Re: Completion Review Report for
Proposed License Termination of
Radioactive Material License R03024

COMPLETION REVIEW REPORT

Facility Name: O'Hern Project

Figure 1: Site Layout

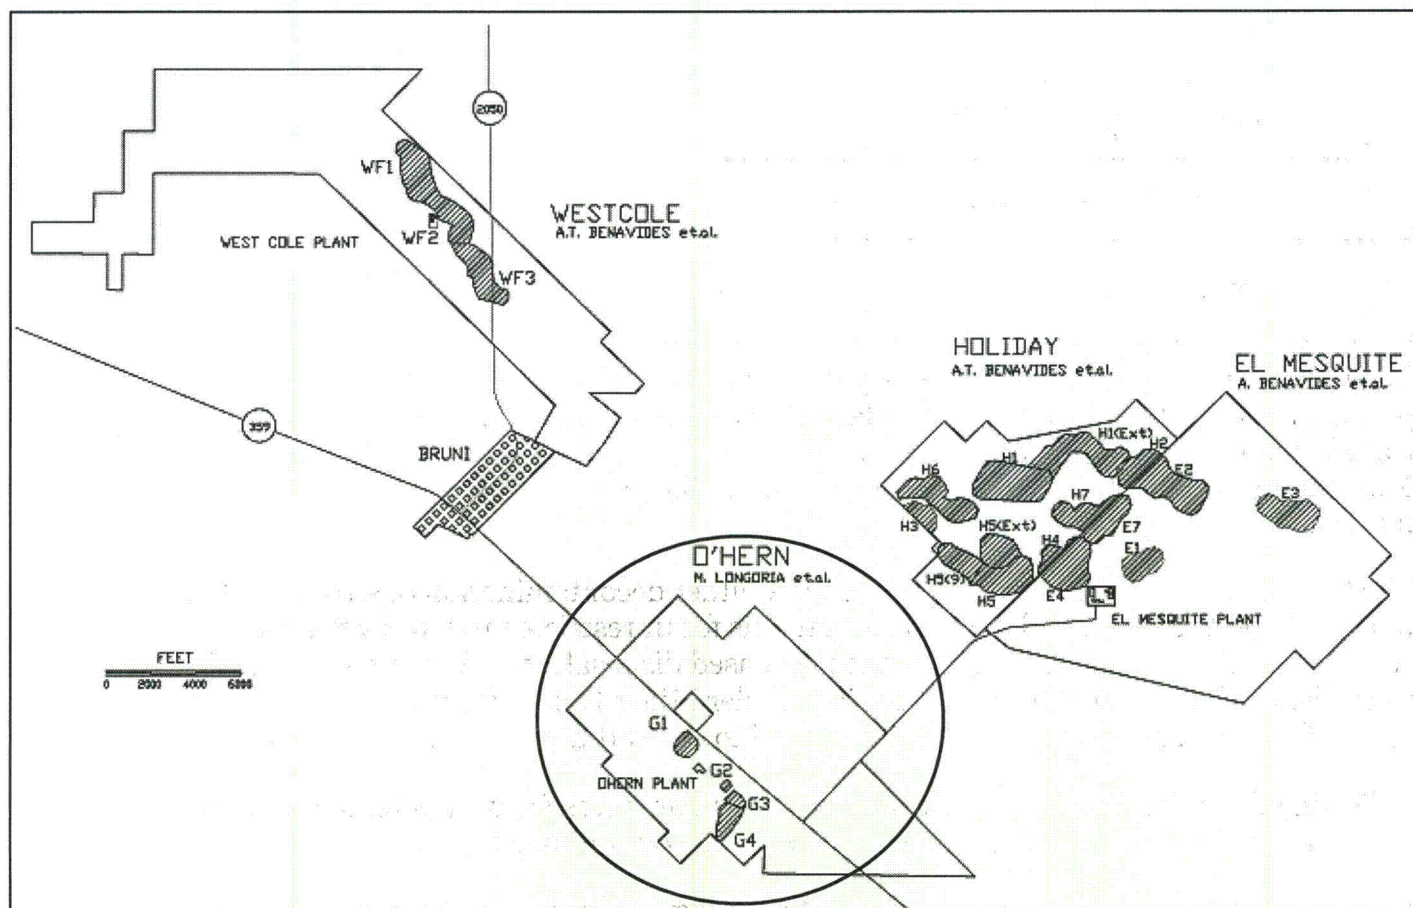
Additional: Stephen Poy made a comment in a phone discussion regarding the site's layout, therefore a map was added detailing the relative locations of the Holiday/El Mesquite, O'Hern and released West Cole Site.
